Final Acceptance Punchlist
El Paso County – Department of Public Works - Stormwater Section

Project Name:	Tamlin RV Boat and Storage
EDARP Filing Number(s):	PPR1945, CON213
ESQCP Number:	ESQ213
Attendees:	DPW SW: Joshua Augustenborg, Ben Jones DPW Development Services: None Developer: Ned McDonald
Date of Walk-Thru:	10/11/2023
Walk-Thru Number:	1

Photo 11: Tailwater basin is not installed per plan detail. Reference sheet 4 of 10 on the GEC.

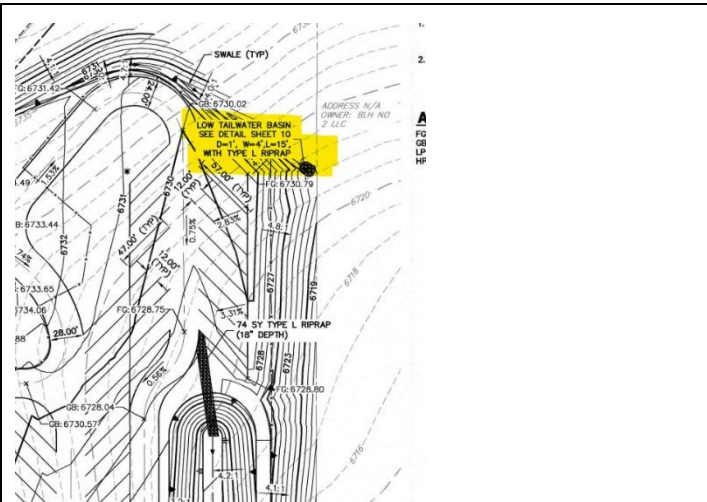
- Tailwater basin is not installed per plan detail. Reference sheet 4 of 10 on the GEC. Reference Photo #12.
